Clash Gour Airspace Change Proposal

ACP-2021-046

Stage 2 Stakeholder Engagement Document

Date: 4th July 2022
Revision: Issue 2
Ref: 71609 020

Figure 1 - Proposed TMZ on LOS Radar Display

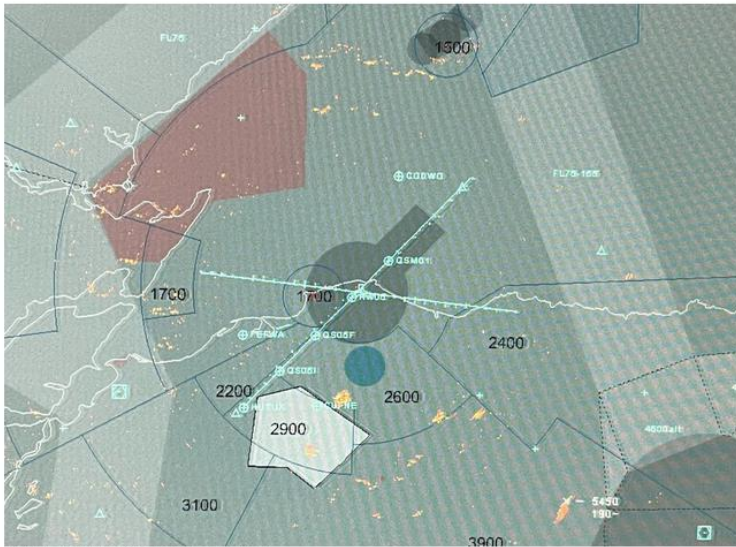
Figure 1 depicts the Lossiemouth AoR with one of the proposed RAG blanked/TMZ area to the south plotted (note this is rough plotting, no guarantee of accuracy). The extended centrelines and RNP procedure map overlays are visible, as well as the Easterton Gliding area (blue circle south of the MATZ). Existing Wind Turbine developments already create a challenge when operating IFR to the south of LOS (clutter visible) for approaches to RWY05, with 2x developments already in situ in the vicinity of the proposed Clash Gour. One of the existing areas of clutter would be covered by the proposed TMZ however the other would not as it is just on the NE edge between TMZ and Easterton.

The presence of the overland TMZ and associated blanking potentially in such close proximity to (and potentially overlapping) existing published IFR arrival/departure procedures may be unacceptable to MOD and they will therefore be seeking further guidance about what is permissible under current regulations and policy. However, if it were to be deemed acceptable, the dimensions of the area must be simple in shape and contain a buffer (size would need to be safety assessed to agree).

Any blanked area and associated TMZ would need to be checked against WAM coverage to ensure there are no gaps or areas of poor coverage that would render aircraft invisible to the controller. As WAM is not yet in service, this is difficult to verify; however, when there is greater clarity on the option(s) to be proposed at stage 3 of the ACP then a request can be made to the relevant authority. An assessment on the performance of the STAR NG radar would also need to be made, to identify the likely impact of the wind turbine on the sensor and what is required to mitigate it, whilst remaining within the bounds of its Release to Service and not undermining the Terminal ATC Operating Safety Case. In the event of a loss of WAM (planned or unplanned maintenance, random failures etc.) the blanking would mean any aircraft operating in the TMZ would not be shown and therefore an ATC Service could not be applied. Operating IFR to runway 05 when Primary (STAR NG) only, is a safety concern to Lossiemouth.

All IFR approaches to RWY05 will be impacted (PAR, TACAN, SRA) and the blanked area would limit Surveillance Radar Approaches to a northerly feed-in, which would limit flexibility and reduce the effectiveness of the service being provided. The TMZ location would funnel non-cooperative traffic to the north, which would put it into conflict with traffic on IFR approaches to RWY05, as well as IFR departures from RWY23, whereas without the TMZ they can freely route to the south of the approach/departure lane. It will also impact RNP procedures (not yet published but in progress), the TACAN Hold for RWY05 and likely to impact ATS provision for departures on the MID23 South. It should be noted that any impact to Lossiemouth procedures may have a knock-on impact to Inverness ATC procedures.
